5. **CASE 22.130, 327 BROADWAY, House, c1860 (BROADWAY)**
2½-story; pedimented end-gable; house; with later 19th C. shallow window bay and entry porch.
CONTRIBUTING

Project: Multi-Family Residence
Address: 327 Broadway, Providence, RI 02909
Date: 5 October 2022
Re: Application Information

NARRATIVE – Scope of Work

A2.2

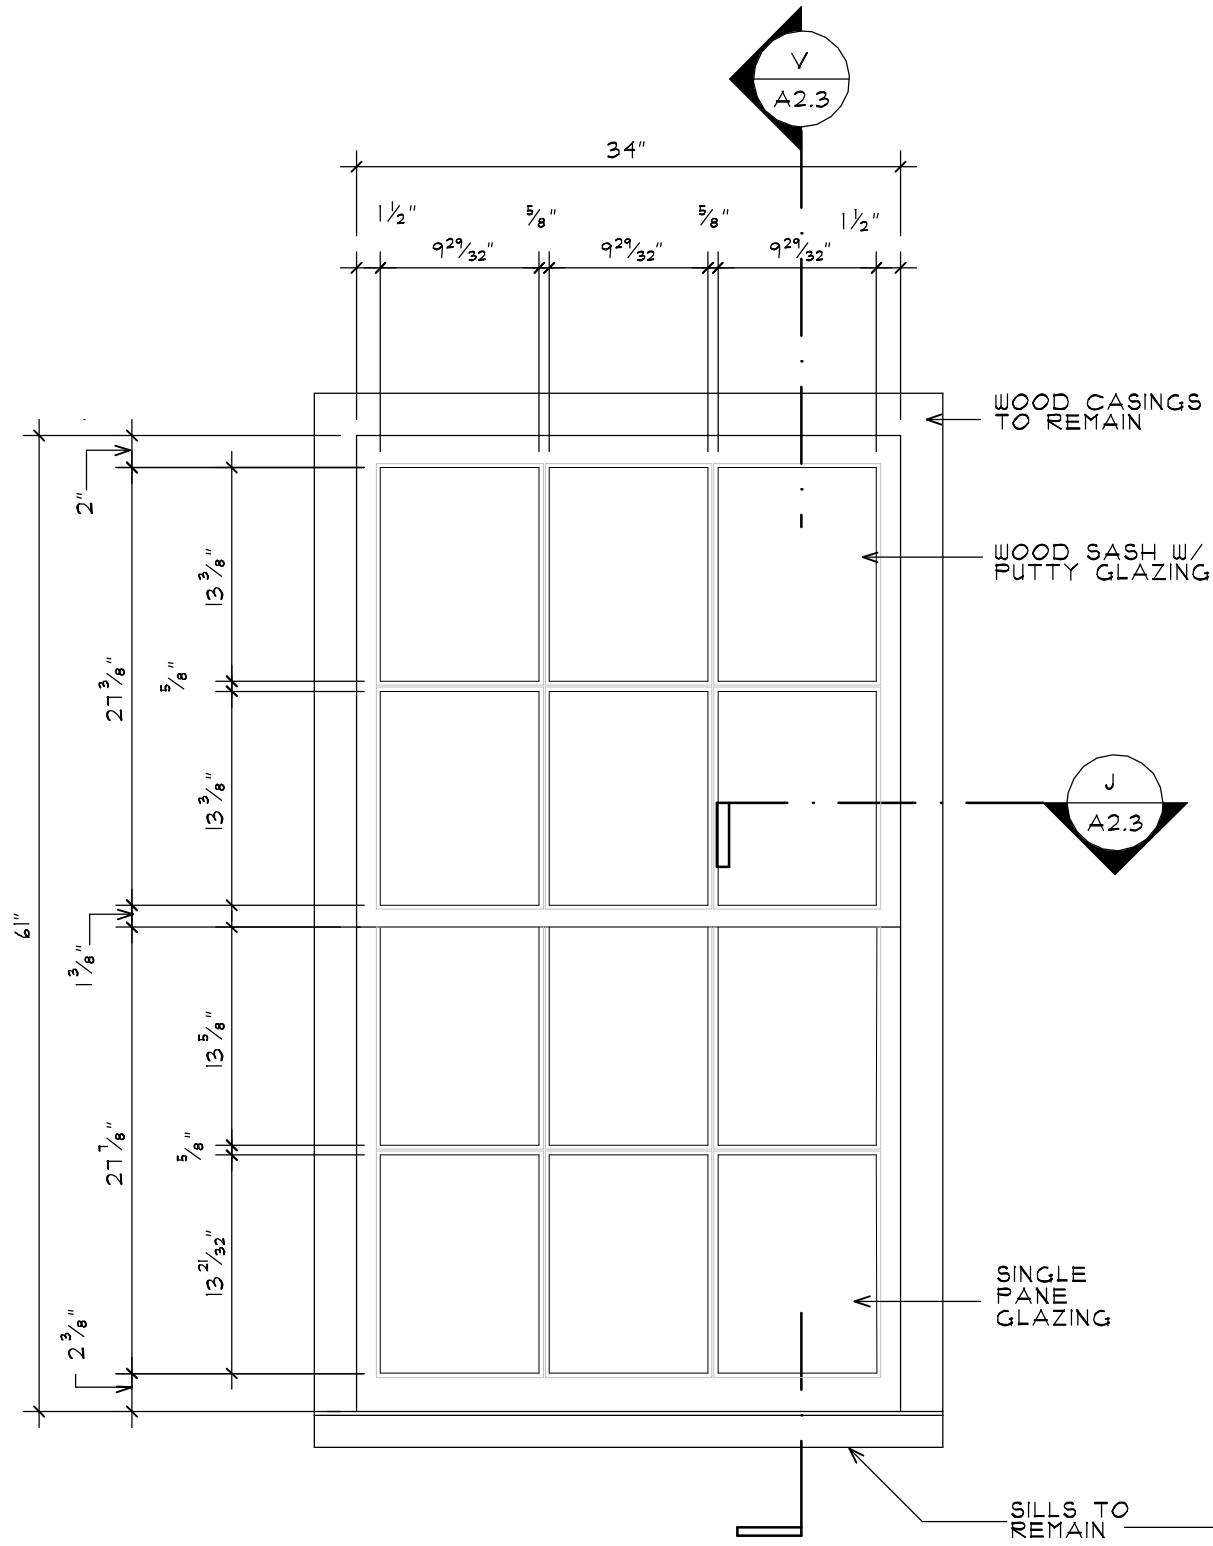
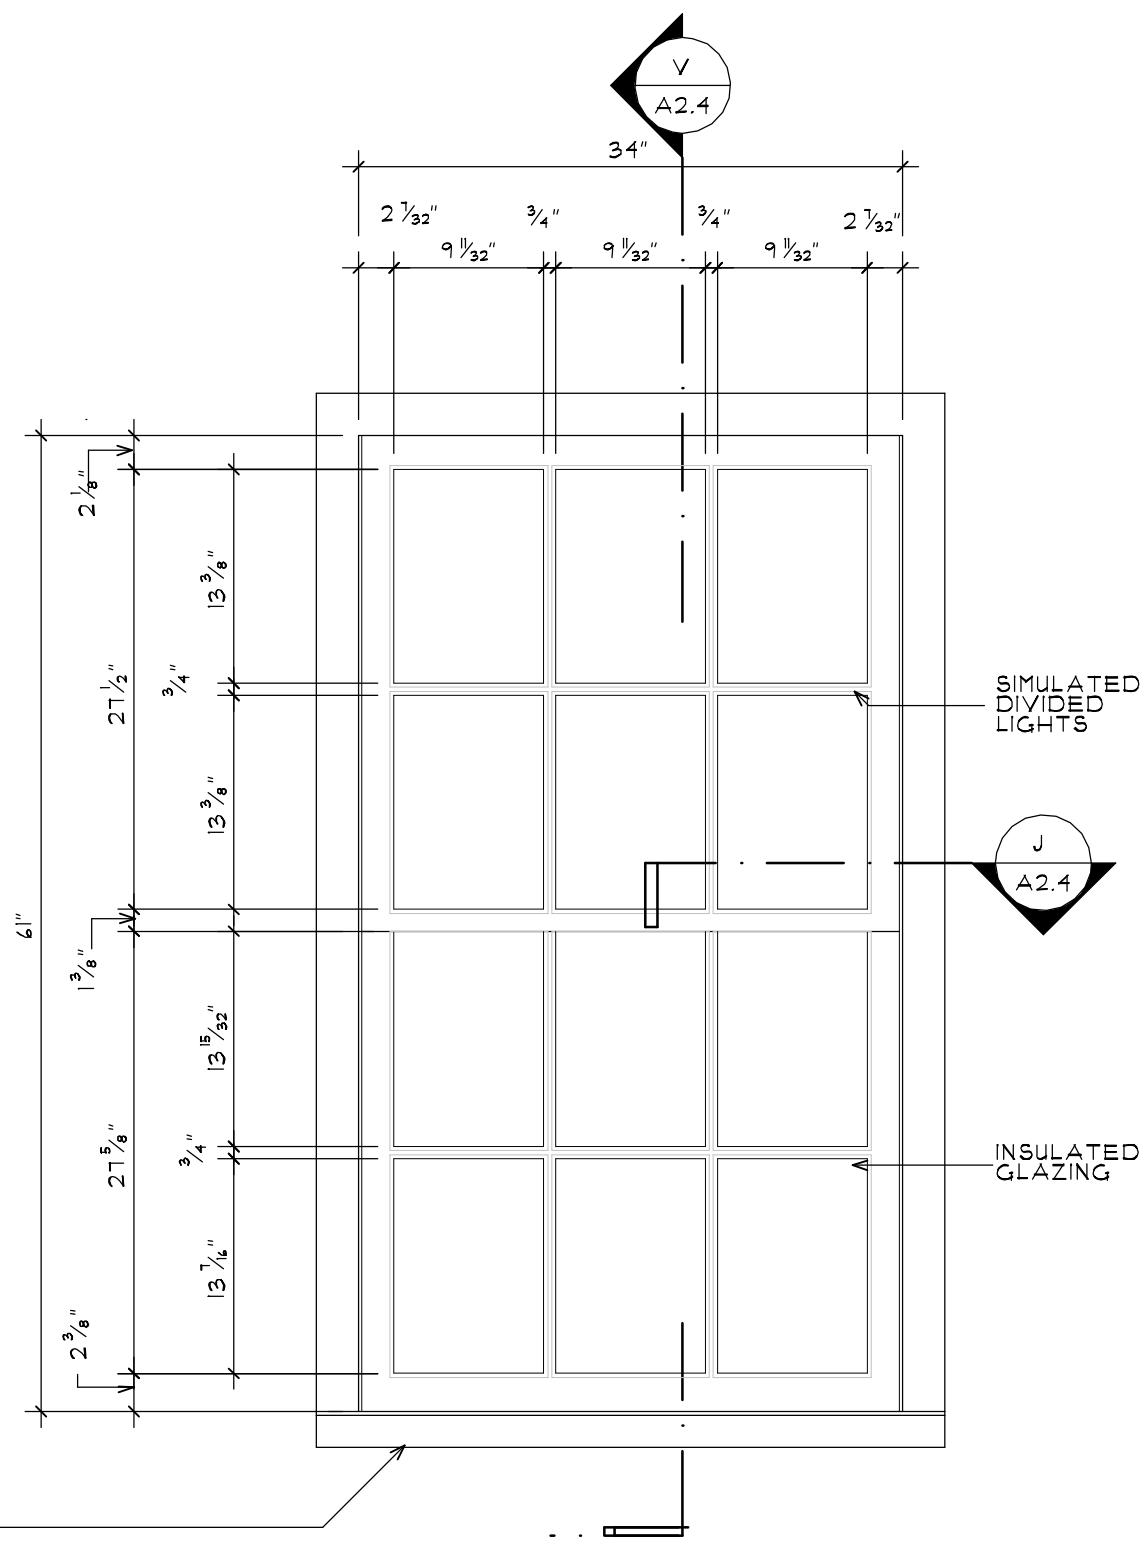
be matched. The difference in glass area reduction is 3% for unit "A". From the exterior, the new sashes, along with removal of the storm windows, will result in windows which are close to the original in size, function, appearance and profile depth with windows within the wall plane, which is diminished by the storm windows.
